From: Jim Muenzenmeyer
Sent: Saturday, December 31, 2016 7:53 AM
To: Dan Koski; Greg Minikel
Subject: RE: Calumet - South 41st St
Attachments: Calumet - South 41st St.pdf

Calumet - South 41st St

From: Greg Minikel
Sent: Tuesday, January 03, 2017 2:40 PM
To: Jim Muenzenmeyer; Dan Koski
Cc: Sonja Birr; Randy Junk; Mark DeZeeuw
Subject: RE: Calumet - South 41st St

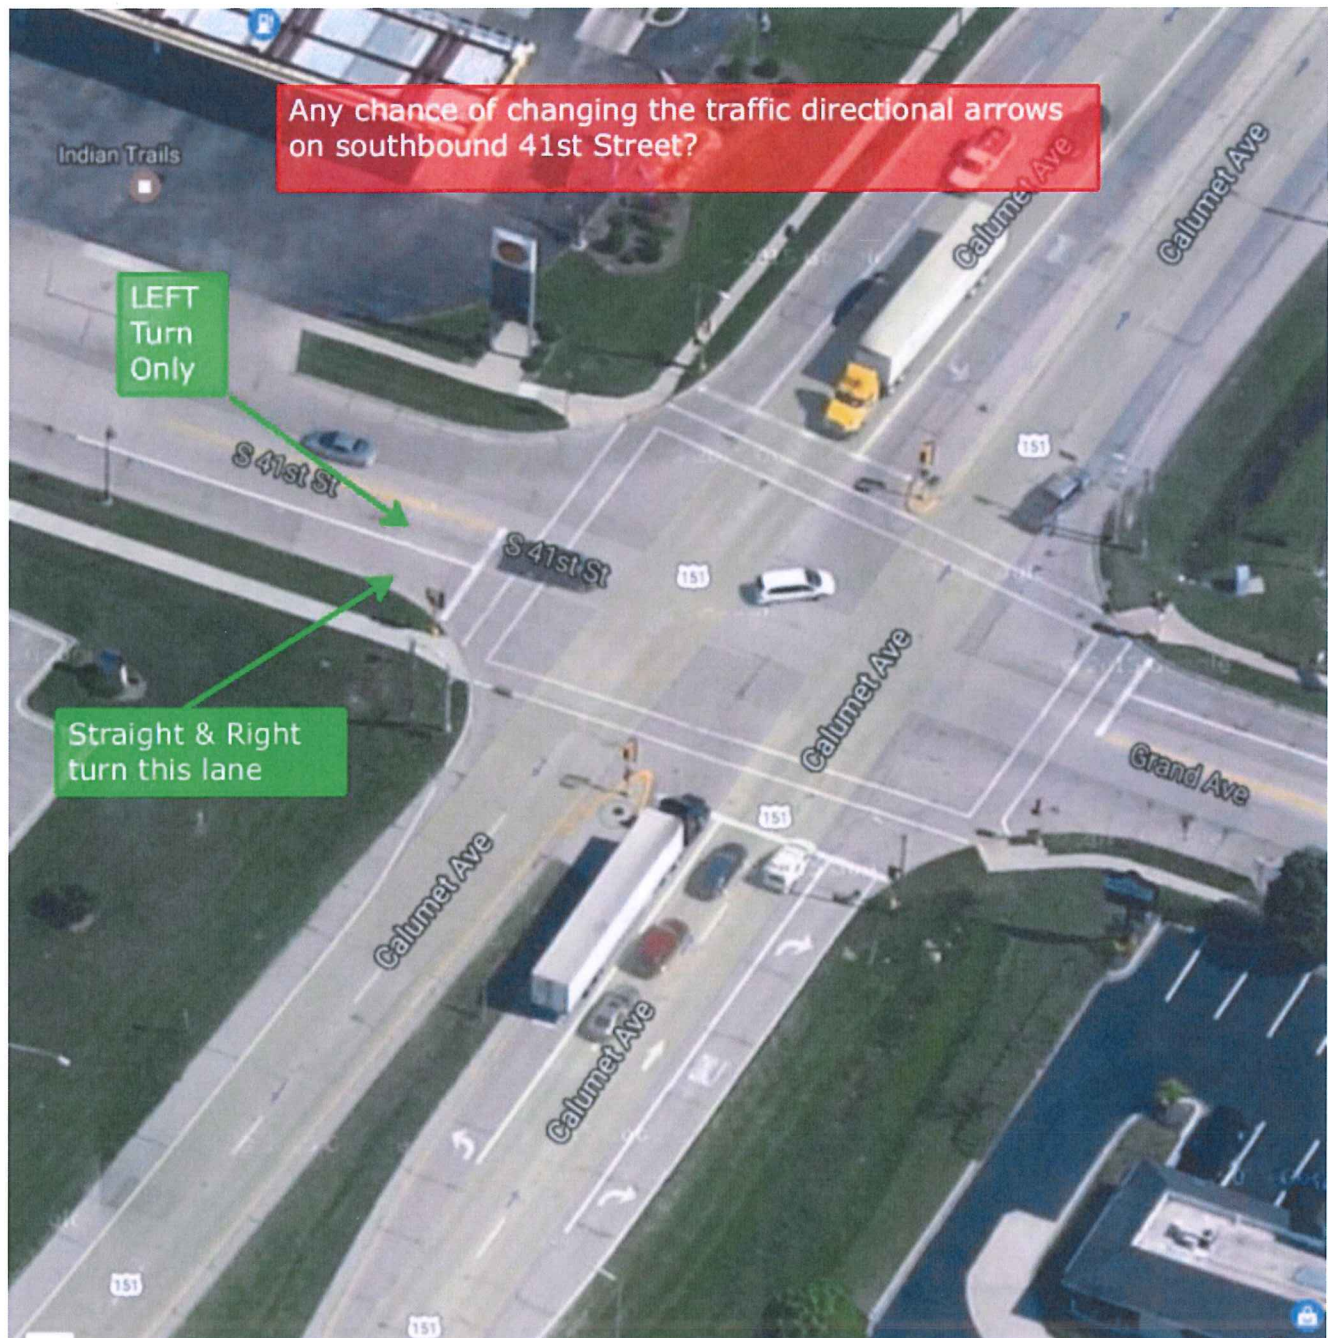
Could you guys take a look at this? While training for the new routes, we noticed quite a backup of traffic in the left lane of S 41st Street traveling SE as it crosses Calumet. Currently, the right lane is a right turn only lane. The left lane in that direction is a left turn and straight. Twice we missed our ability to go straight through that intersection while we waited for the left turning vehicles to clear.

Please discuss amongst yourselves to see if the right lane could be a right turn and straight and make the left lane left turn only.

Traffic turning left backs up in the left lane of travel blocking through traffic now. Proposed change would allow right turn traffic to unload (right on Red) thus not blocking through traffic.

As we discussed, let's send this to the PI Committee for the February 13th meeting. My recommendation would be to only change the one direction or only the S. 41st St. leg of the intersection. There are far too many right turns from Grand Ave. to make the same change on that side.
